Access Compliance Report

Public Rights-of-Way

Intersection ID: 17581	Main Street: MCNAIR_RD	Cross Street: RAMA_RD	Location:	SE
ADA ID: 548A626EA082	Ramp Type: PerpDiag	Initial Pass/Fail: Fail	Overall Compliance: No	Severity Score: 55

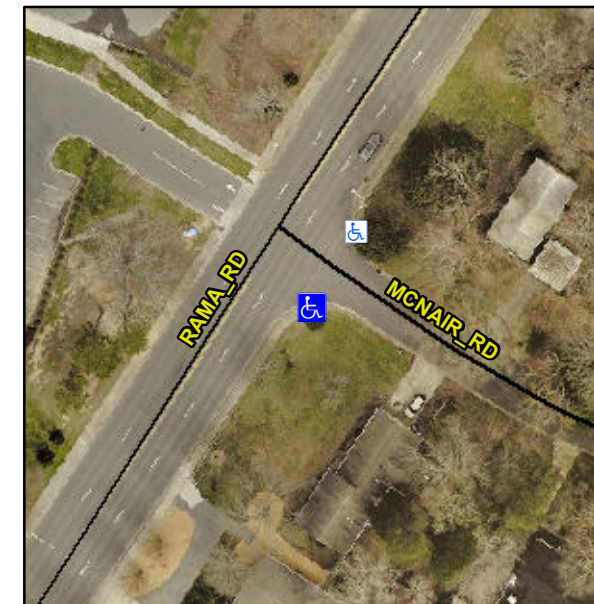
Not Found, R304.5.1, R304.2.2, R304.5.3

Compliance	Description	Data	Compliance	Description	Data
N/A	Ramp Length (in)	54.0	No	Ramp Slope (%)	8.6
No	Ramp Width (in)	35.0	No	Ramp XSlope (%)	7.6
N/A	Flare Type LT	N/A	N/A	Flare Type RT	N/A
N/A	Flare Slope LT (%)	N/A	N/A	Flare Slope RT (%)	N/A
N/A	Flare Traversable LT?	N/A	N/A	Flare Traversable RT?	N/A
N/A	Landing Length (in)	N/A	N/A	DWS Provided?	N/A
N/A	Landing Width (in)	N/A	N/A	DWS Contrast?	N/A
N/A	Landing Slope (%)	N/A	N/A	DWS Length (in)	N/A
N/A	Landing X Slope (%)	N/A	N/A	DWS Full Width?	N/A
N/A	Landing Curb? (Y/N)	N/A	N/A	DWS Offset (in)	N/A
N/A	Shared Landing?	N/A			
N/A	Gutter Ponding?	N/A	N/A	Gutter Slope (%)	N/A
N/A	Gutter Lip Ht (in)	N/A	N/A	Gutter X Slope (%)	N/A
N/A	Painted X Walk1?	No	N/A	Painted X Walk2?	No
	X Walk 1 Direction	To NE		X Walk 2 Direction	To NW
N/A	X Walk 1 Width (in)	N/A	N/A	X Walk 2 Width (in)	N/A
	X Walk 1 Slope (%)	5.4		X Walk 2 Slope (%)	9.6
	X Walk 1 X Slope (%)	8.5		X Walk 2 X Slope (%)	0.4

Remove & Replace Curb Ramp With Two New Directional Ramps or Equivalent.
